UNITED STATES PATENT AND TRADEMARK OFFICE

Office Action Summary

10/733,307

MURAOKA ET AL.

ATTACHMENT # 1

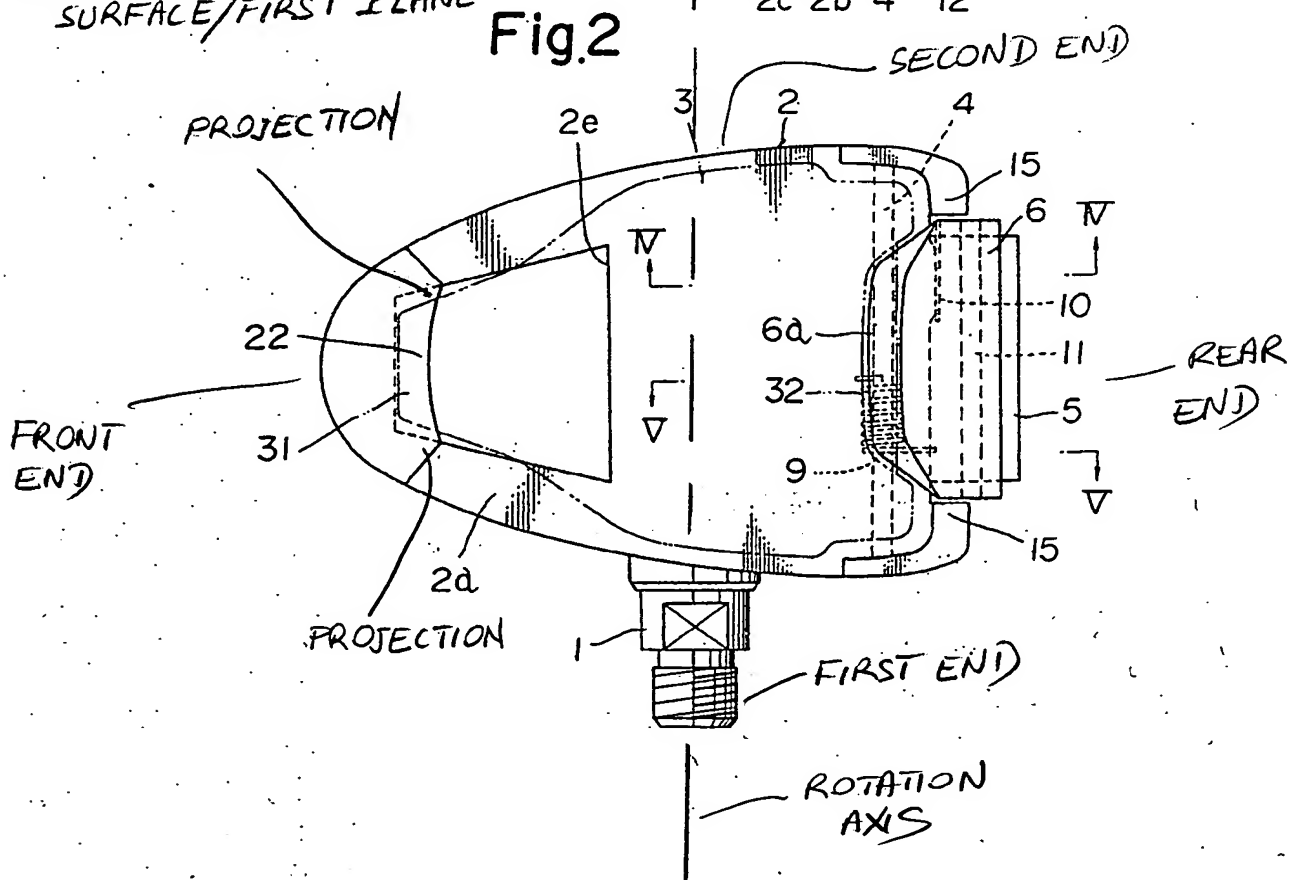
a pedal shaft 1 having a first end (see Attachment # 2) adapted to be coupled to a bicycle crank and a second end (Att. # 1) with a center rotation axis (Att. # 1) extending between said-first and second ends;

a pedal body 2 rotatably coupled to said second end (Att. # 1) of said pedal shaft 1 about said center rotation axis (Att. # 1) of said pedal shaft 1, said pedal body 2 having a front end (Att. # 1) and a rear end (Att. # 1) with said front end (Att. # 1) of said pedal body 2 being configured and arranged to include a sole guide portion 22 that assists in rotating said pedal body 2 about said pedal shaft 1, said sole guide portion 22 including a pair of laterally spaced projections (Att. # 1) located on said upper surface of said pedal body 2 adjacent a forwardly facing tip surface, said sole guide portion 22 including a pair of laterally spaced projections (Att. # 1) located on a forwardly facing tip surface of said pedal body; and

Regarding claim 31, said front clamping member 22 includes a downwardly facing front cleat engagement surface (Att. # 1) disposed in a first plane (Att. # 1), and said rear clamping member includes a downwardly facing rear cleat engagement surface (Att. # 1) disposed in a second plane (Att. # 1) that is offset from said first plane (Att. # 1) of said front cleat engagement surface (Att. # 1).

Regarding claim 32, said front clamping member 22 includes a rearwardly facing front pedal control surface (Att. # 1), said rear clamping member 6, 62 includes a forwardly facing rear pedal control surface (Att. # 1).

Regarding claim 34, said first plane (Fig. 1 of Att. # 1) of said front cleat engagement surface 22 is closer to said center rotation axis (Att. # 1) than said second plane (Att. # 1) of said rear cleat engagement surface (Att. # 1) as measured in a direction perpendicular to said first and second planes (Att. # 1).

ATTACHMENT # 2

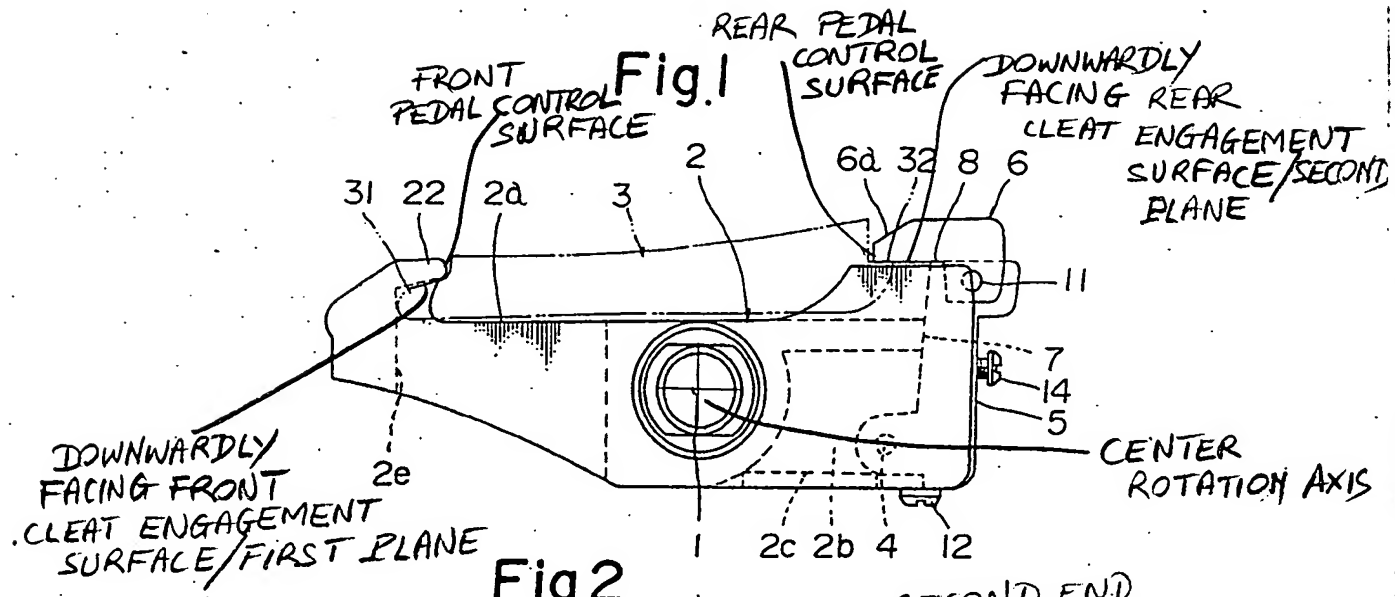
a pedal body 20 rotatably coupled to said second end of said pedal shaft 52 about said center rotation axis A of said pedal shaft 52, said pedal body 20 having a front end and a rear end with said front end of said pedal body 20 being configured and arranged to include a sole guide portion 64 (Fig. 5) that assists in rotating said pedal body 20 about said pedal shaft 52, said sole guide portion 64 including a pair of laterally spaced projections (see Attachment # 2) located on said upper surface 4 of said pedal body 20 adjacent a forwardly facing tip surface, said sole guide portion 64 including a pair of laterally spaced projections (Att. # 2) located on a forwardly facing tip surface of said pedal body 20; and

Regarding claim 31, said front clamping member 24 includes a downwardly facing front cleat engagement surface 66 (Fig. 8. *Id.*, col. 6, line 27 *et seq.*) disposed in a first plane P₁ (Att. # 2), and said rear clamping member 26 includes a downwardly facing rear cleat engagement surface 82 (Fig. 1) disposed in a second plane P₂ that is offset from said first plane P₁ of said front cleat engagement surface 66.

Regarding claim 32, said front clamping member 24 includes a rearwardly facing front pedal control surface 60 (Fig. 8, Att. # 2), said rear clamping member 26 includes a forwardly facing rear pedal control surface 78 (Fig. 6, Att. # 2).
